**REQUEST FOR TENDERS  
LIBRARY REFURBISHMENT  
RFQ 34 (2022-06)  
ADDENDUM #1**

**LIBRARY  
RE-CONFIGURATION**

**1 PROPOSED LAYOUT**  
 SCALE: 1/4" = 1'-0"

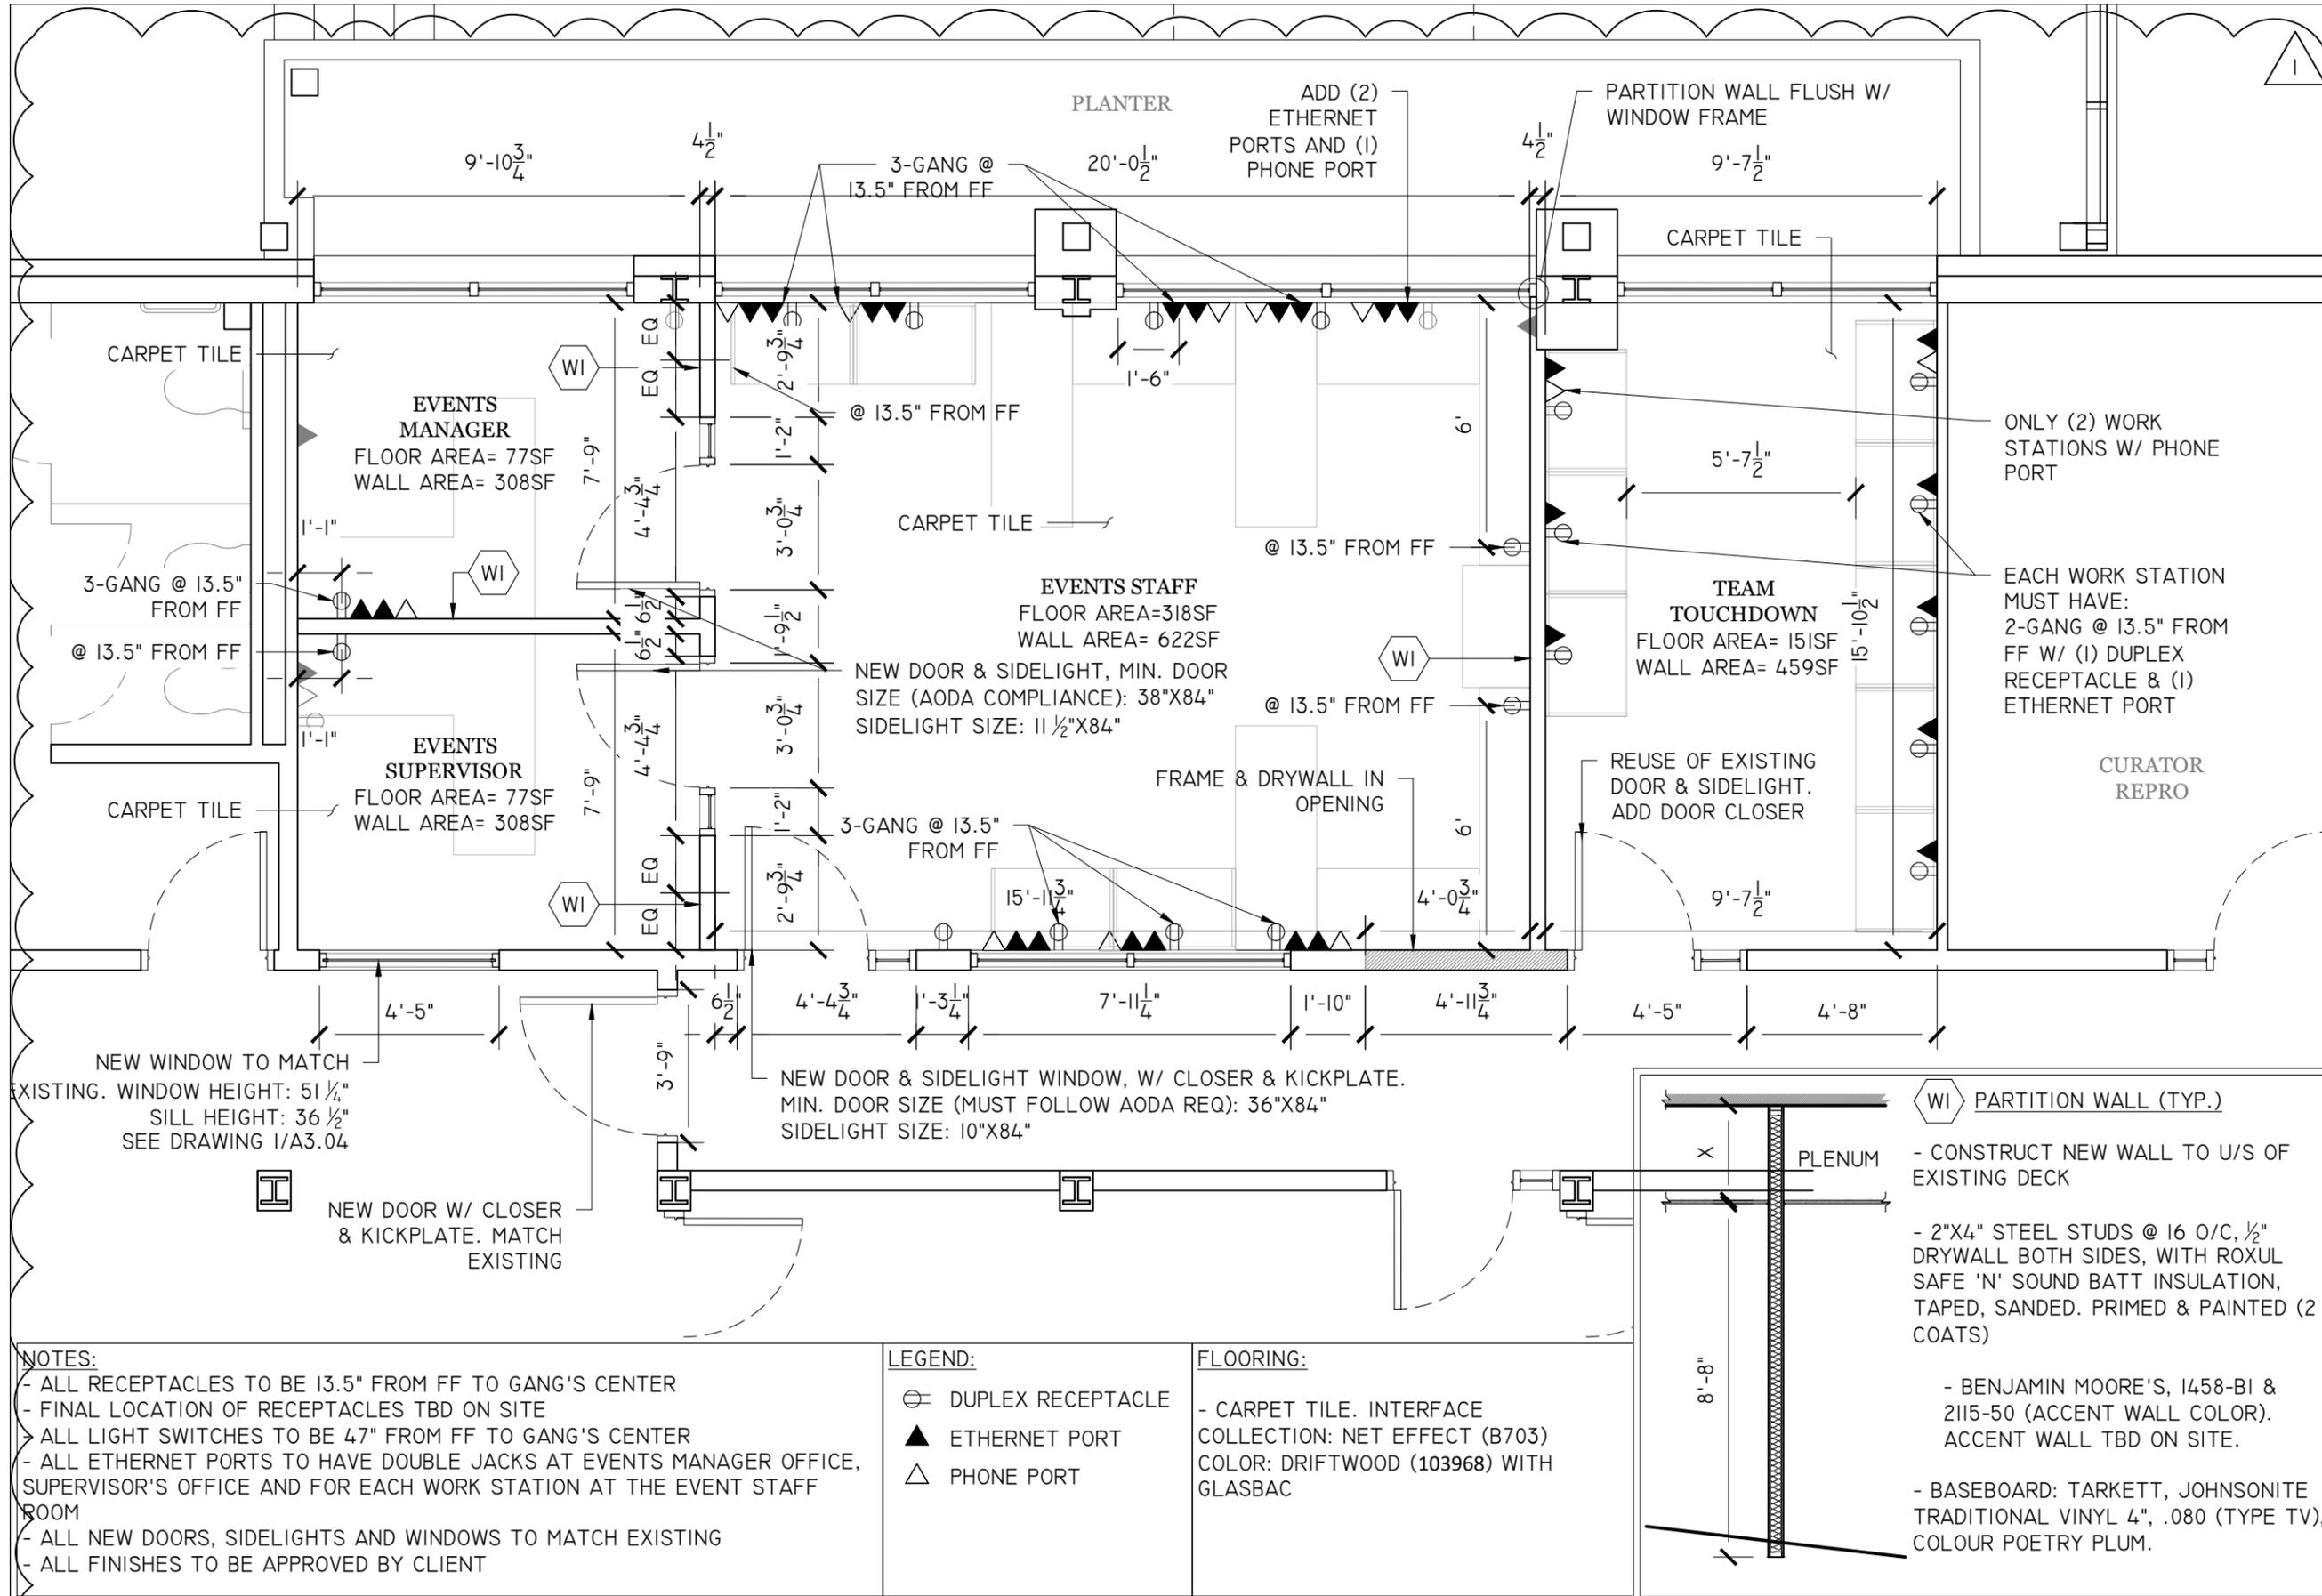
2. **QUESTION:** Will the new partitions require sound batt in the stud space?

9. **QUESTION:** Do you want a door closer on the new corridor door or office doors?

**RESPONSE:** Yes. Use Roxul Safe 'n' Sound for the entire partition. Client must approve if different.

**RESPONSE:** Yes. We want door closers on both doors from corridor into rooms. Do not use closers at the interior offices' doors. See plan A3.01.

**A3.03**

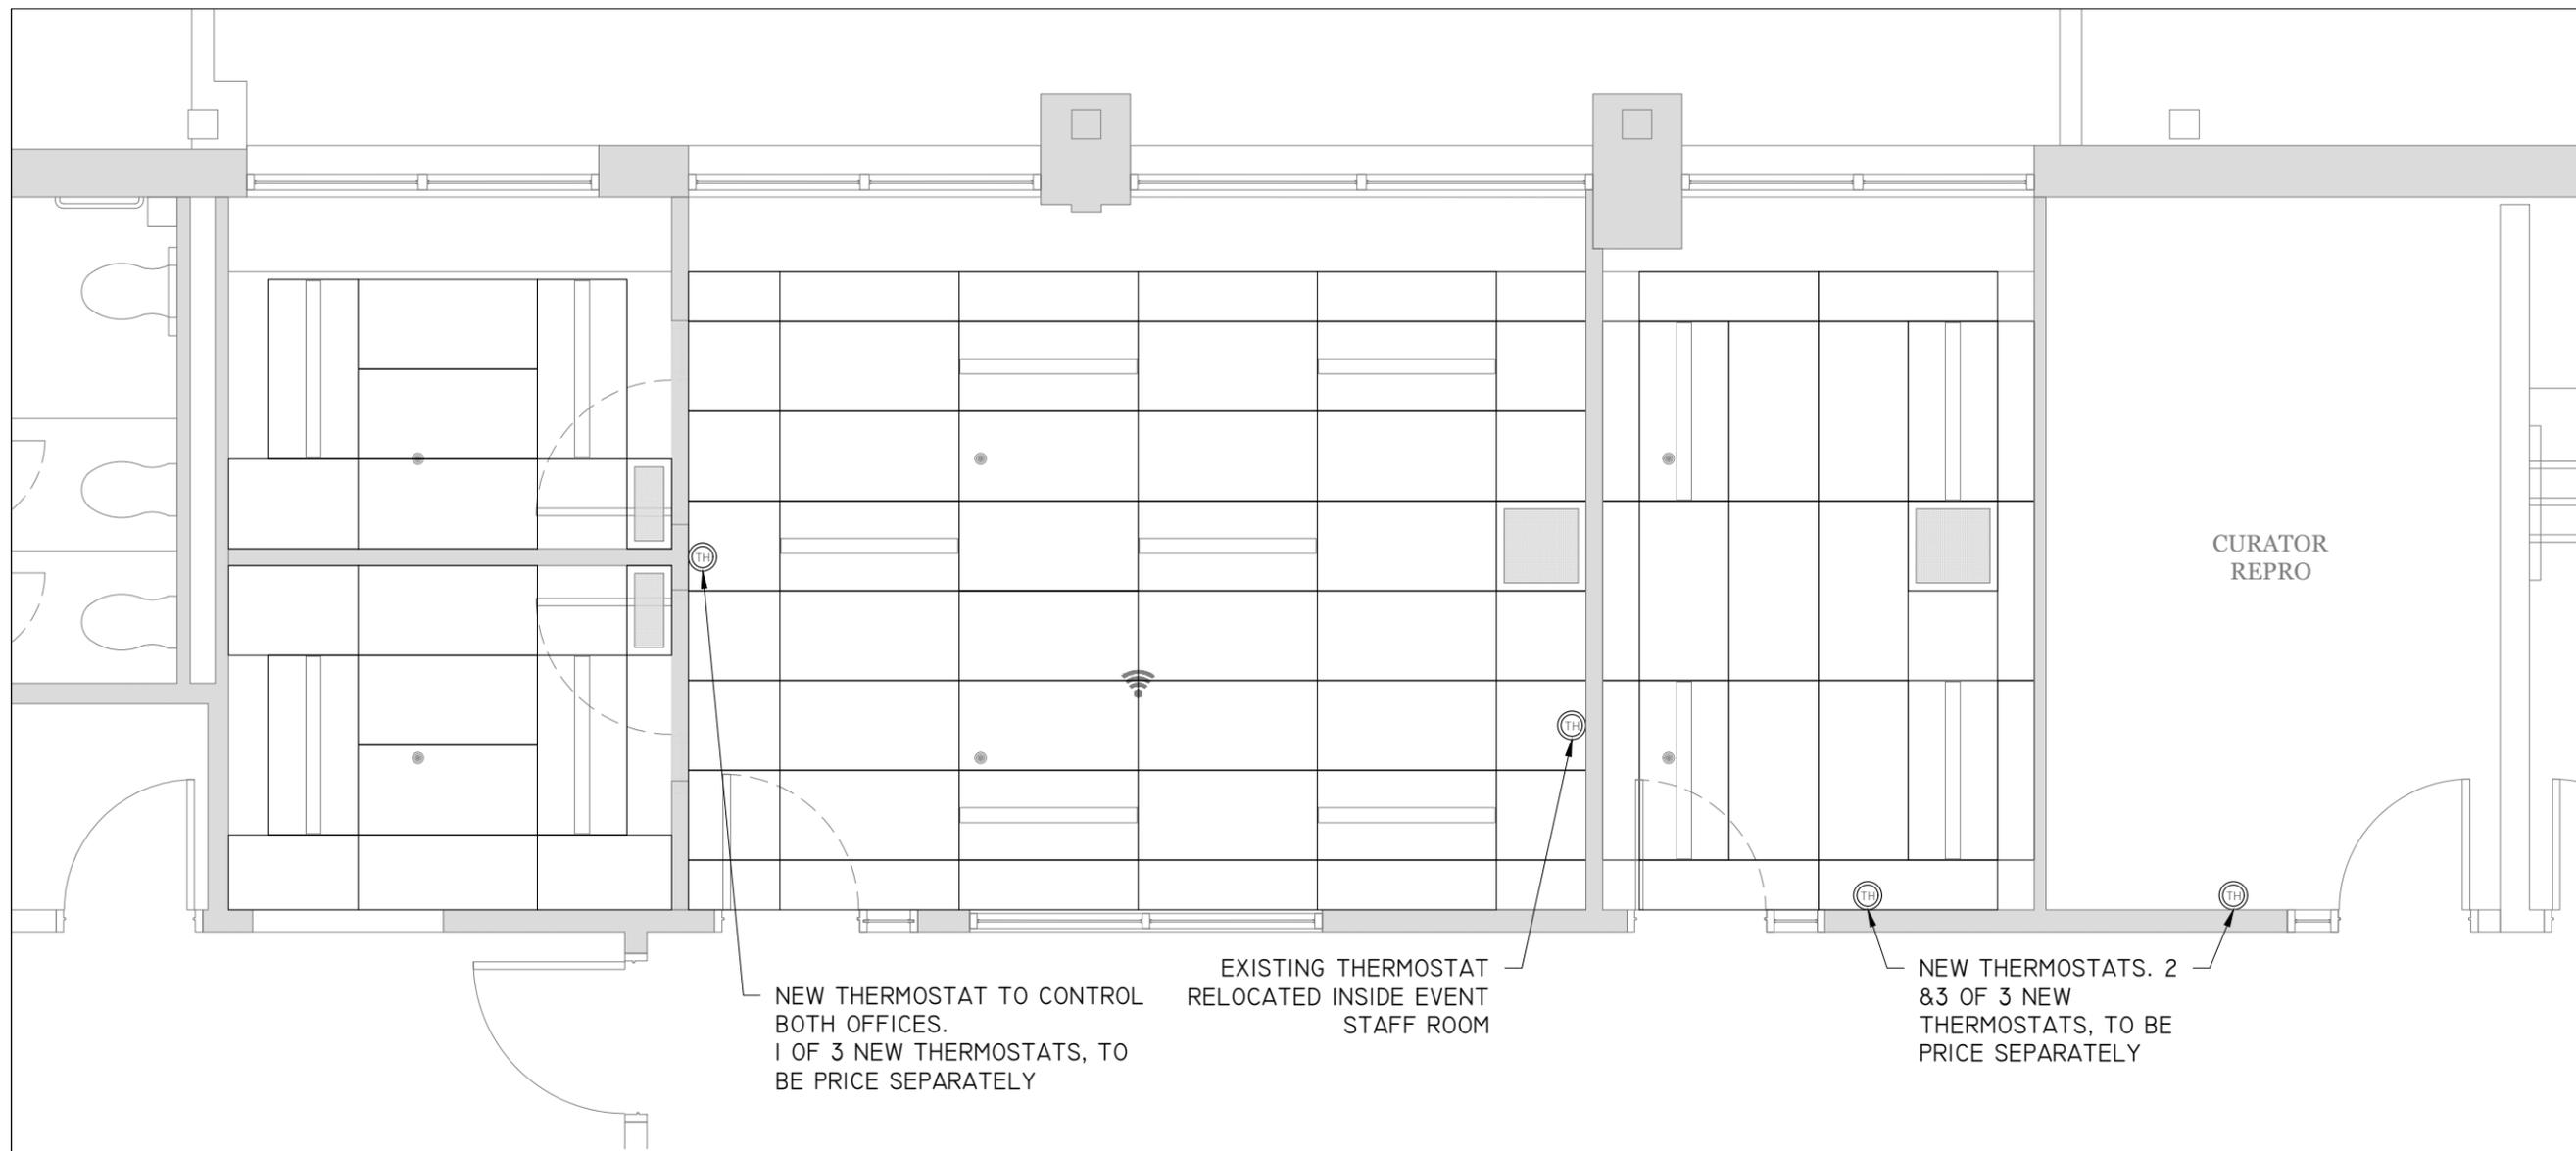
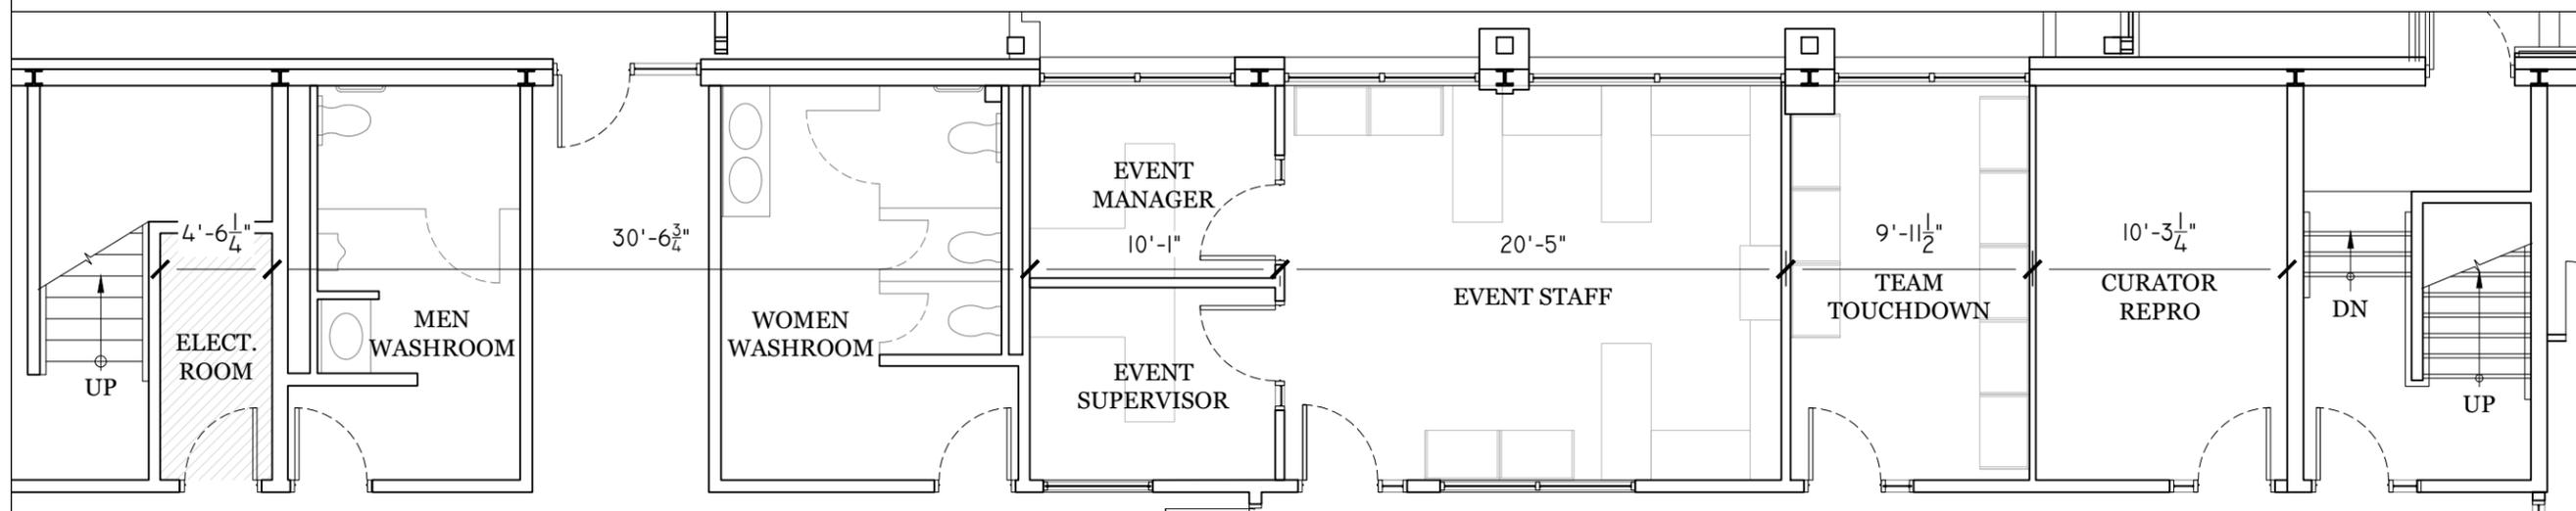
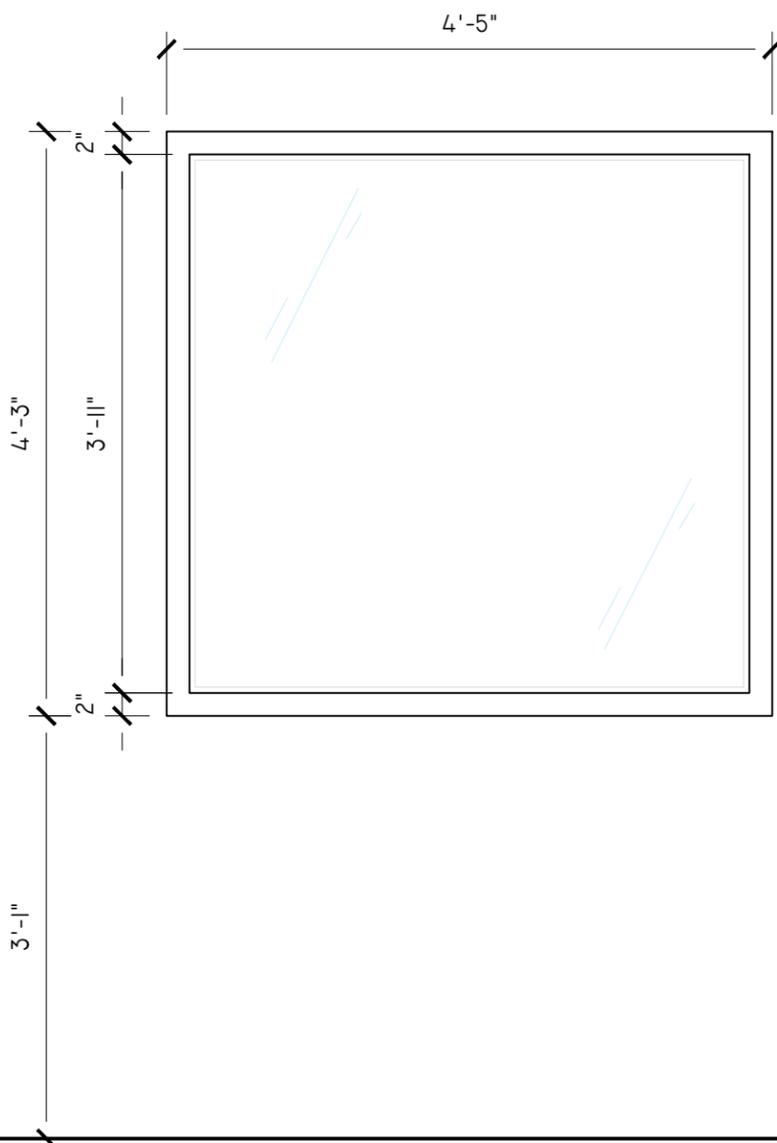
1. **QUESTION:** Telephone/Data – on previous jobs we have provided a box, EMT & pull string to the ceiling space. Please confirm that is the requirement here.

6. **QUESTION:** T-stats – please confirm only 1 since there is only one VAV box in the ceiling.

**RESPONSE:** Contractor to run the phone/data cabling to the closest switch. See electrical room location on plan A3.03.

**RESPONSE:** The existing thermostat will be relocated into the “event staff room”. Please, quote for relocation of only 1 thermostat (the existing one) controlling the five locations. Separately quote the additional price option of adding three additional new thermostats w/ vav boxes and all associated hardware/equipment: 1 controlling both office spaces, 1

controlling the team touchdown space and 1 controlling the curator room. The quote must include all associated mechanical equipment.

A3.04

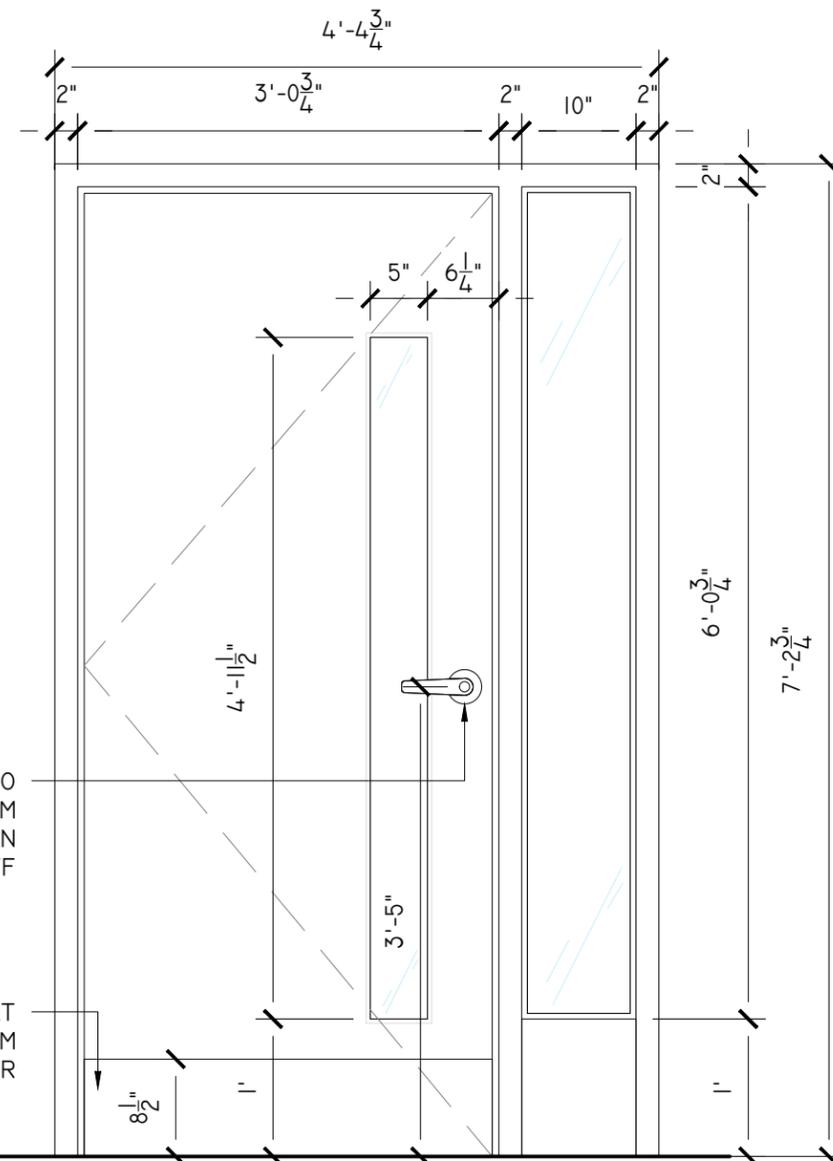
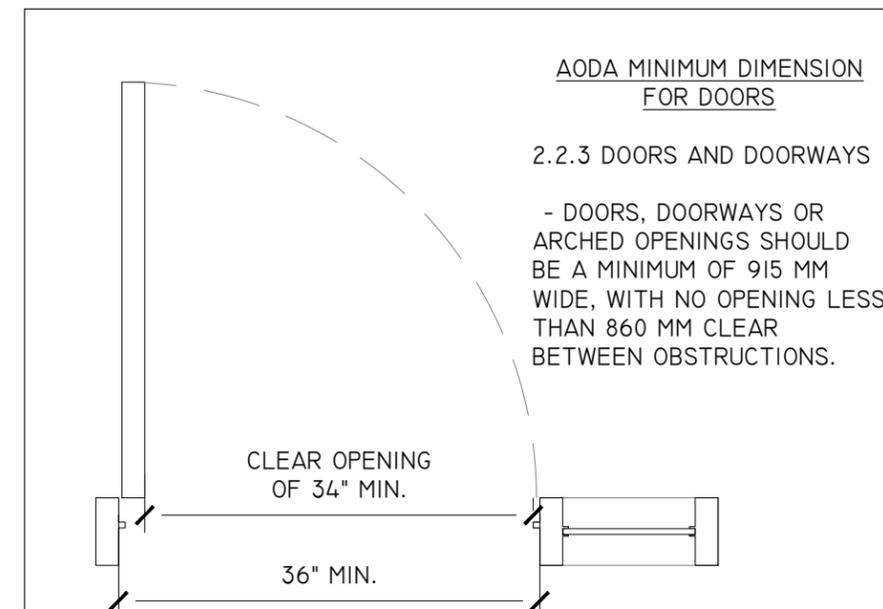
5. **QUESTION:** Please confirm sidelite is 10" wide.

12. **QUESTION:** Are the door frames Hollow metal, or Aluminum?

14. **QUESTION:** Can you confirm that the new window frame is HM?

**RESPONSE:** Yes. See the new plan A3.03 – Door and window schedule

**RESPONSE:** Solid wood core, with plastic laminate on both sides. Refer to door schedule A3.04

**RESPONSE:** Yes. Refer to the new plan A3.03 – Door and window schedule
